Interoffice Memorandum

May 12, 2022

Subject: Review of model for Black Rock Services, LLC – HP-2 HMA Plant

Permit # 3443

Figure 1. Black Rock Services HP-2 HMA source layout.

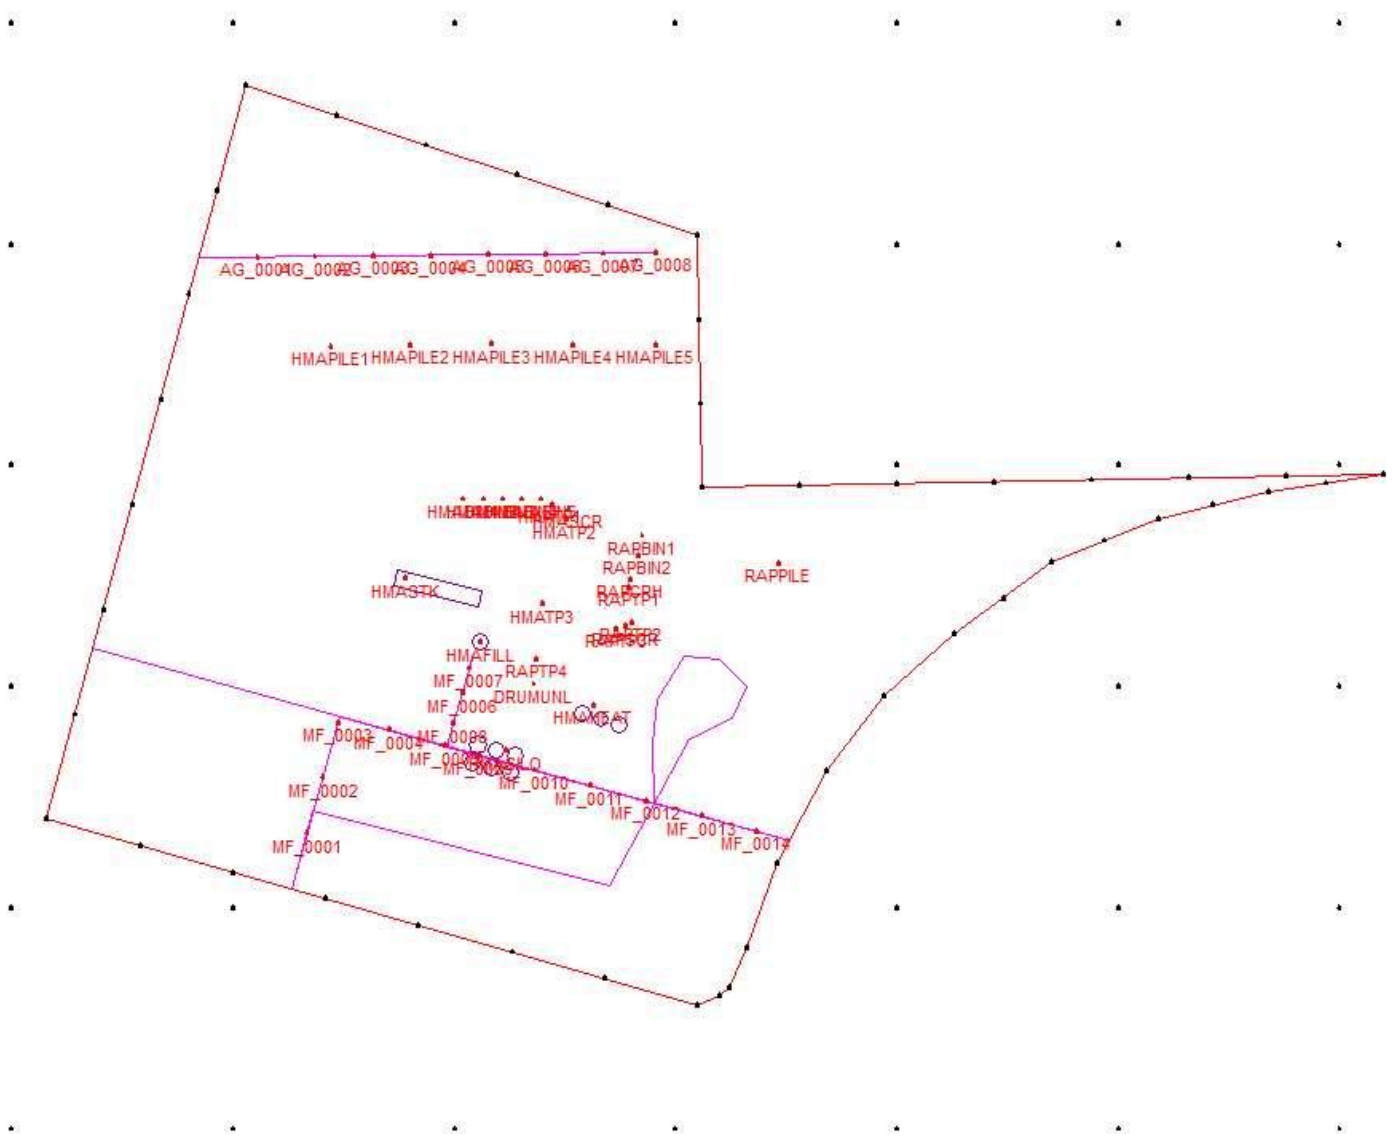
10. The drum dryer/mixer (Unit 16) particulate emissions are controlled by a baghouse (Unit 16b). The baghouse stack has a height of at least 23.2 feet, a diameter of no more than 4.6 feet and an exit velocity of at least 74.89 feet/second. The baghouse stack must be located at least 200 feet from the western fence, at least 300 feet from the northern fence, at least 340 feet from the eastern fence and at least 230 feet from the southern fence as modeled and shown in Figure 1.

13. The five aggregate storage piles must be located in the northern part of the facility but south of the AG haul road. The westernmost aggregate storage pile must be located at least 100 feet from the western Black Rock fence. The one RAP storage pile must be located in the eastern part of the facility at least 45 feet from the northern boundary and at least 100 feet from the closest part of the curved eastern boundary.

Figure 2. Paved haul roads AG and MF.

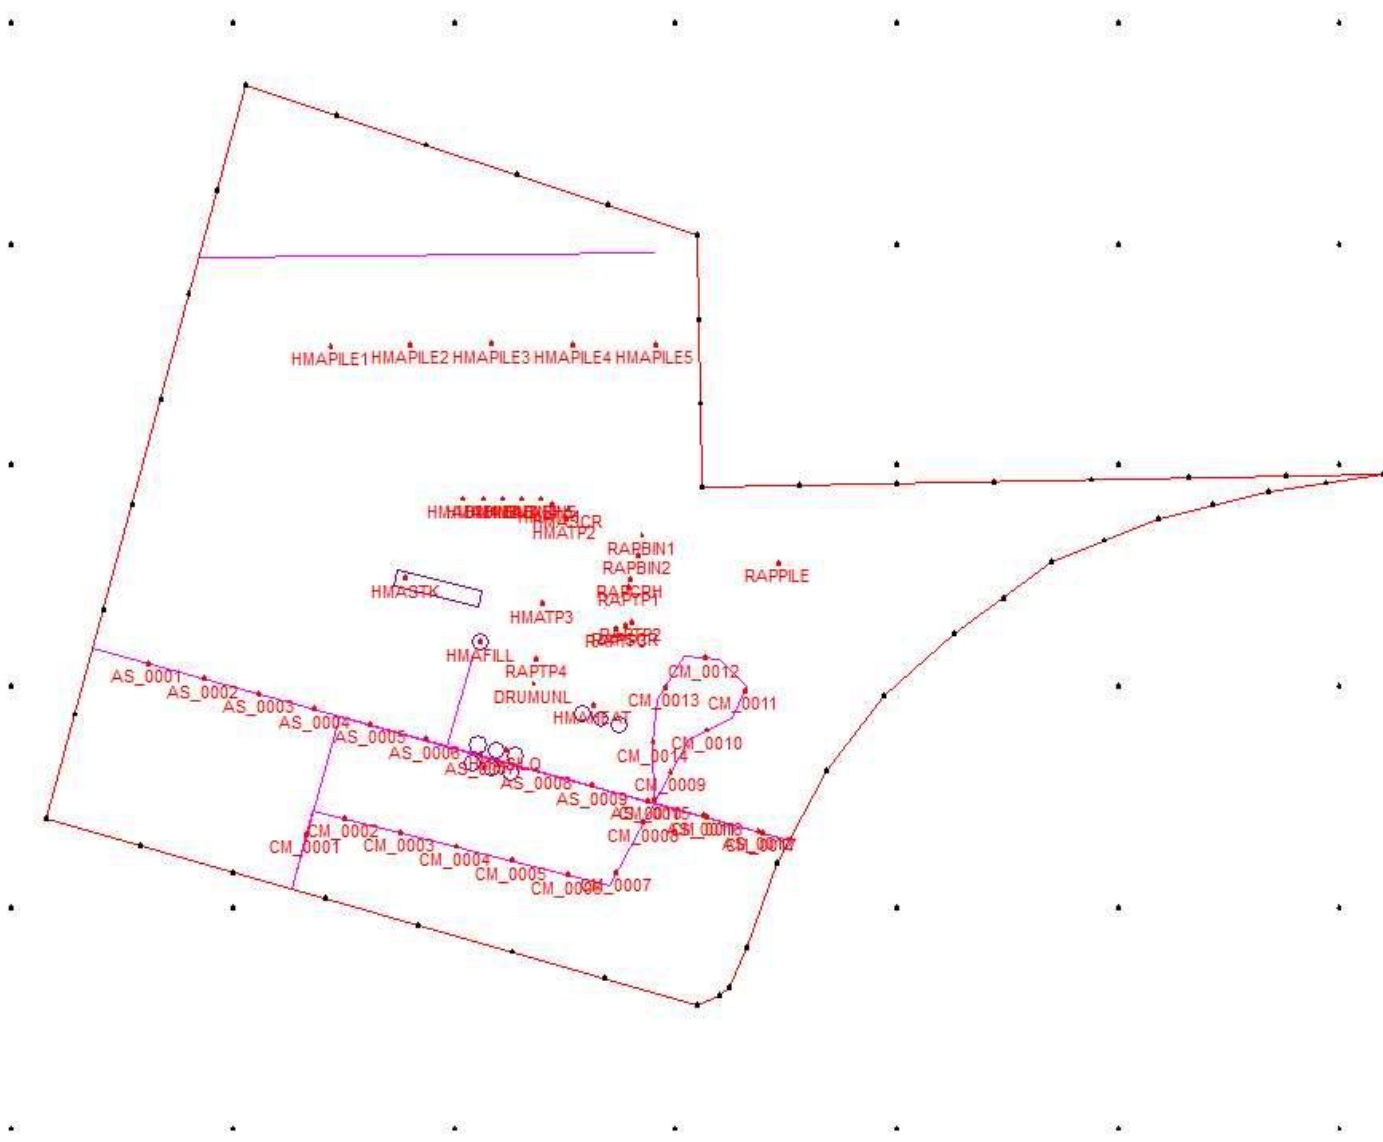
7. The mineral filler trucks travel on the road identified as Haul Road Paved MF (Fig. 1 & 2). The aggregate trucks travel on the road identified as Haul Road Paved AG (Fig. 1 & 2). The asphalt cement, Evotherm and RAP trucks all travel on the road identified as Haul Road Paved CM (Fig. 1 & 3).

Figure 3. Paved haul roads AS and CM.

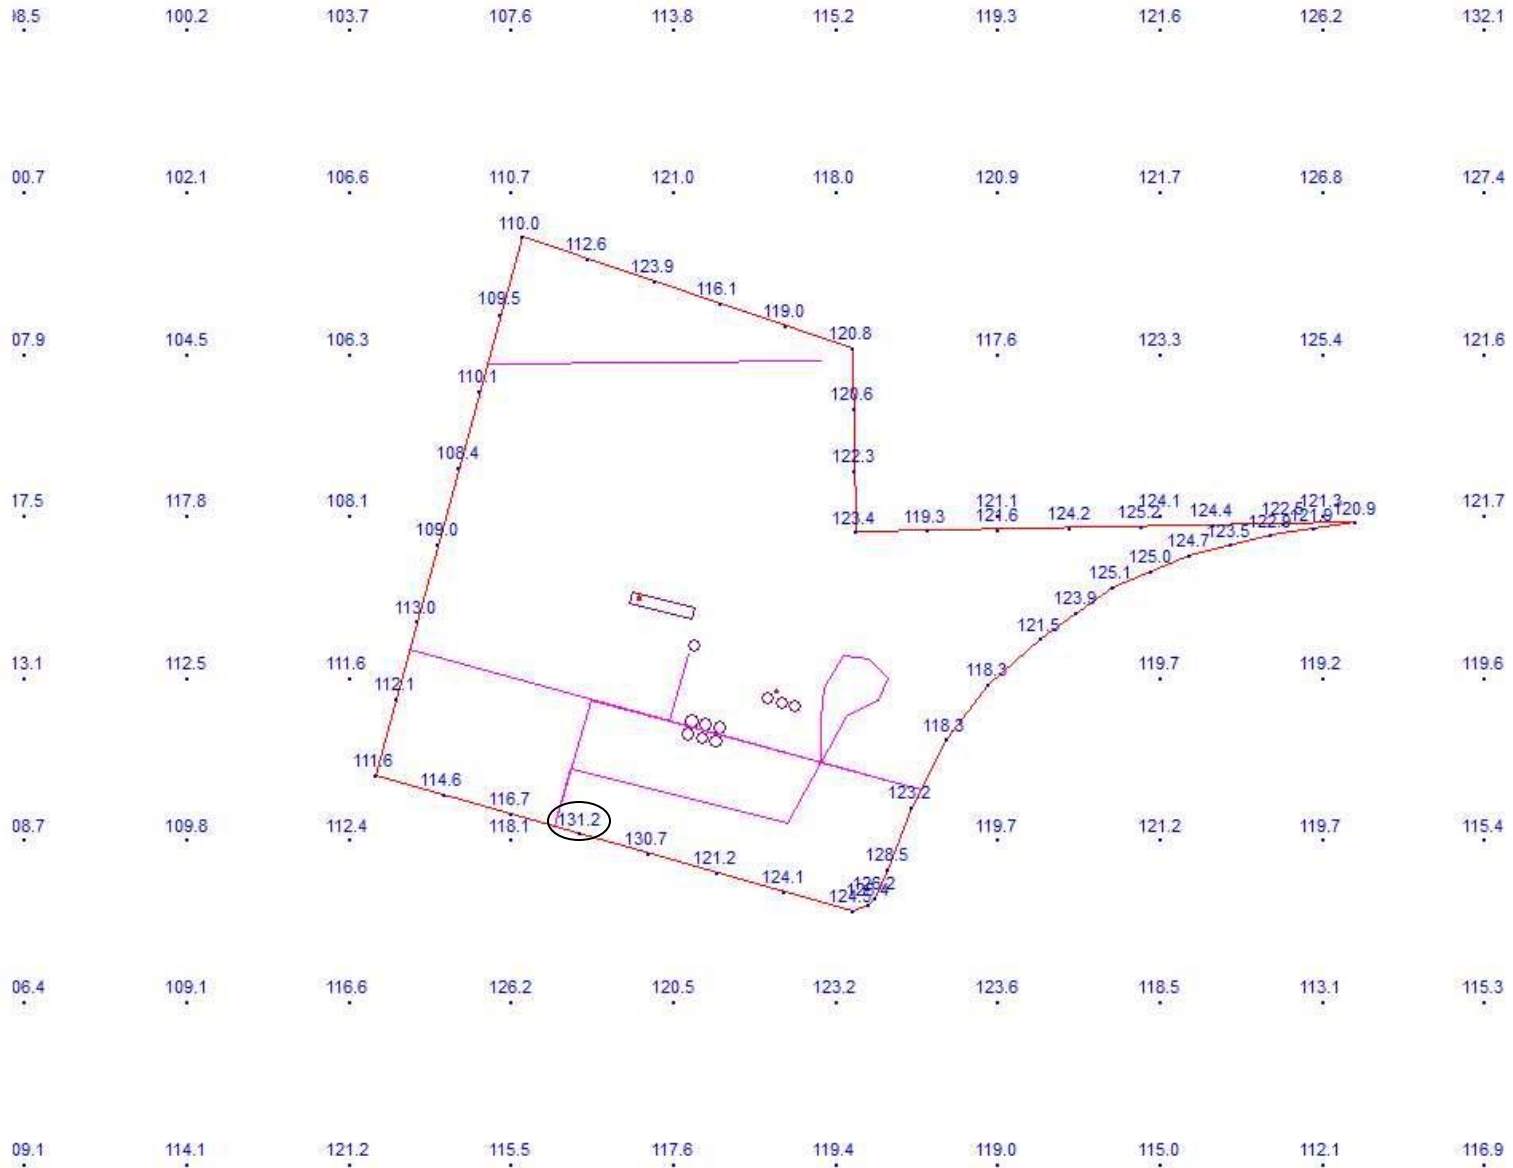
6. The limits for haul trucks are as follows: 32 trucks/hour total may enter and leave the facility based on the emission calculations and modeling that was performed. Of those 32 trucks/hour, 16 trucks/hour may be asphalt trucks traveling on the Haul Road Paved Asphalt (AS) (Fig. 1 & 3) to be loaded with asphalt and 16 trucks/hour may be aggregate, asphalt cement, Evotherm, mineral filler or RAP trucks traveling on the Haul Road Paved AG, CM or MF (Fig. 1, 2 & 3).

Figure 9. 1-hour H₂S results.

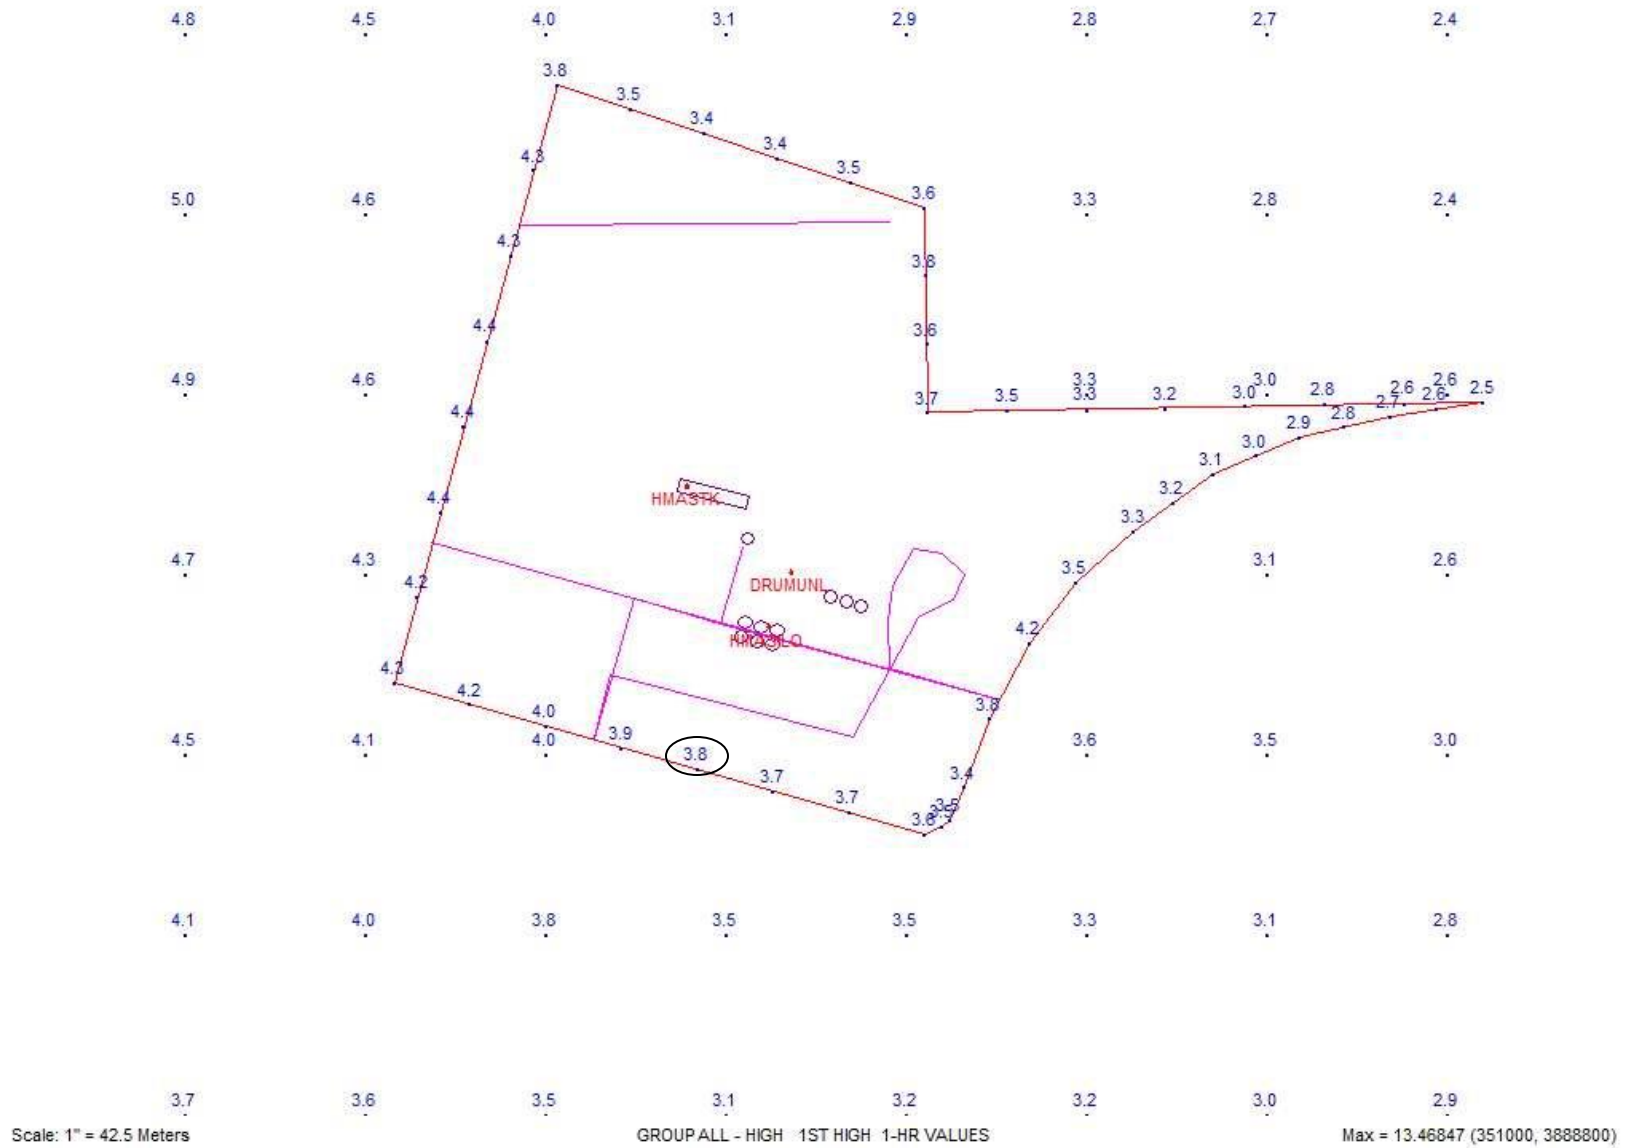
The revised H₂S model run by EHD showed maximum modeled impacts west of HollyFrontier but there was no significant contribution from Black Rock at these receptors. The highest 1st high modeled impact at a receptor with a significant contribution from Black Rock was 3.8 $\mu\text{g}/\text{m}^3$ on the southern Black Rock fence at the receptor with the highest modeled impact from Black Rock. This is the same location as the high modeled result submitted by Montrose but the value is higher due to the inclusion of surrounding sources as described above and the high modeled result is almost all contributed by HollyFrontier.
